Public Library

Town of Manchester-by-the-Sea ADA Transition Plan

February 2020

Institute for Human Centered Design

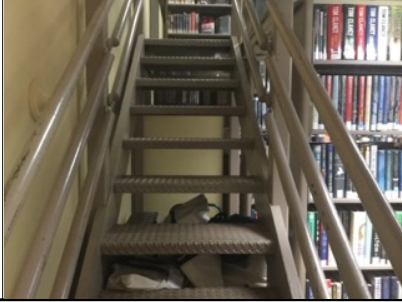
ID	Location	Floor	Room	Element	Type	Photo	Issues	Current Measure	Recommendations	Quantity	Price	Cost Estimation
Approach and Entrance												
Exterior Access Route												
1	Central/ Union Street at Path to Main Entrance	Ext.		Exterior Access Route	Sidewalk		Cross slope > 1:50 (2.00%)	4.5%	Reduce cross slope to be no steeper than 1:50 (2.00%). (Cost for 3'x3' of asphalt to correct slope.)	1	90	\$90
2	Path to Children's Area Entrance	Ext.		Exterior Access Route	Exterior		Level changes > 1/4"	1"	Alter change in level to be 1/4" high max. (Cost for a 3'x3' concrete patch.)	1	144	\$144
3	By Ramp	Ext.		Exterior Access Route	Exterior		Accessible route not provided	-	Ensure an accessible route is provided to the bike rack. (Cost for a 3'x3' concrete patch.)	1	144	\$144
4	Front of Library Near Union Street	Ext.		Exterior Access Route	Walkway		Accessible route not provided	-	Ensure an accessible route is provided to the table and chairs in front of library along Union Street. (Cost based on a 48" wide 30' long stone dust walkway to table area.)	1	960	\$960

5	Near Church Street Ramp	Ext.		Exterior Access Route	Walkway		Accessible route not provided	-	Ensure an accessible route is provided to the pet tie-up area. (Cost based on a 48" wide x 6' long stone dust path.)	1	192	\$192
Access to Goods and Services

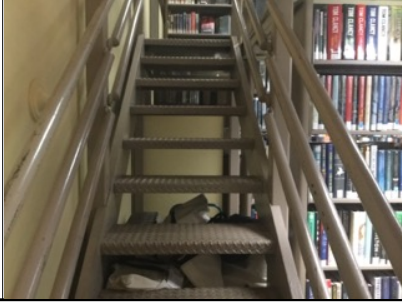
ID	Location	Floor	Room	Element	Type	Photo	Issues	Current Measure	Recommendations	Quantity	Price	Cost Estimation
Means of Egress												
6	Exit to Ramp	1		Means of Egress	N/A		Tactile exit sign not provided Illuminated Int. Symbol of Acc. not provided	-	Ensure tactile exit signs with raised characters and braille are provided at exit doors. Mount signs between 48"- 60" above finished floor located on the latch side of the door. Provide a sign with an illuminated International Symbol of Accessibility (ISA).	1	432	\$432
7	Central/ Union Street Exit	1		Means of Egress	N/A		Tactile exit sign not provided Illuminated Int. Symbol of Acc. not provided	-	Ensure tactile exit signs with raised characters and braille are provided at exit doors. Mount signs between 48"- 60" above finished floor located on the latch side of the door. Provide a sign with an illuminated International Symbol of Accessibility (ISA).	1	432	\$432

Interior Access Route												
8	Main Room	1		Interior Access Route	N/A		Route < 36" wide	30"	Ensure that a clear width of 36" min. is maintained at the accessible route (shift location of large stand).	1	Labor	\$0
9	Path to Stairs to Mezzanine	1		Interior Access Route	N/A		Route < 36" wide	33"	Ensure that a clear width of 36" min. is maintained at the accessible route (relocate items to create a 36" min. wide path to stairs).	1	Labor	\$0
10	Friends of Library Volunteer Area	1		Interior Access Route	N/A		Accessible route not provided	-	Providing an accessible route to the basement Friends of Library area may be technically infeasible. To provide program access, recommend relocating the Friends of the Library area to an accessible location as needed.	1	Labor	\$0
